APPLICATION NO.	FILING DATE	FIRST NAMED INVENTOR	ATTORNEY DOCKET NO.	CONFIRMATION NO.
10/748,695	12/30/2003	Robert Coon	WEAT/0535	2005
	7590 09/24/200 & SHERIDAN, L.L.P.	•	EXAMINER	
3040 POST OAK BOULEVARD, SUITE 1500 HOUSTON, TX 77056			COLLINS, GIOVANNA M	
1100310N, 1X 77030			ART UNIT	PAPER NUMBER
			3672	
			MAIL DATE	DELIVERY MODE
			09/24/2007	PAPER

Application No.	Applicant(s)				
	10/748,695	COON ET AL.				
Office Action Summary	Examiner	Art Unit				
	Giovanna M. Collins	3672				
The MAILING DATE of this communication appears on the cover sheet with the correspondence address Period for Reply						
A SHORTENED STATUTORY PERIOD FOR REPLY IS SET TO EXPIRE 3 MONTH(S) OR THIRTY (30) DAYS,						
 WHICHEVER IS LONGER, FROM THE MAILING DA Extensions of time may be available under the provisions of 37 CFR 1.13 after SIX (6) MONTHS from the mailing date of this communication. If NO period for reply is specified above, the maximum statutory period w Failure to reply within the set or extended period for reply will, by statute, Any reply received by the Office later than three months after the mailing earned patent term adjustment. See 37 CFR 1.704(b). 	ATE OF THIS COMMUNICATION 36(a

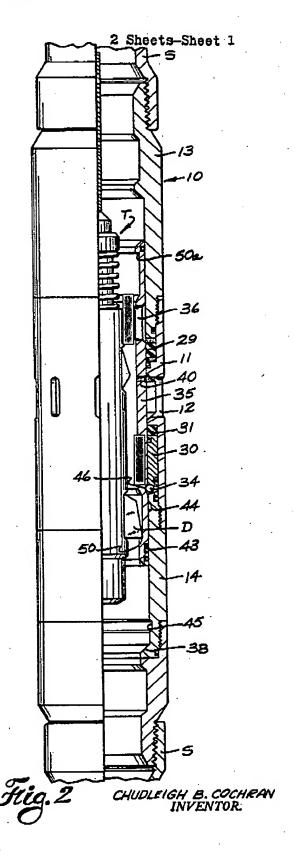
2. Applicant's arguments filed 7/6/07 have been fully considered but they are not persuasive. The applicant argues that the adapter (30) disclosed by Cochran is not greater than the sleeve port (at 36). The applicant is incorrect. Looking at the reproduced Fig. 2. on the next page, the shaded box next to element 30 represents the length of element 30. When this shaded box is shown next to element 36, the shaded box is longer than element 36. Therefore, adapter 30 is longer than sleeve port 36.
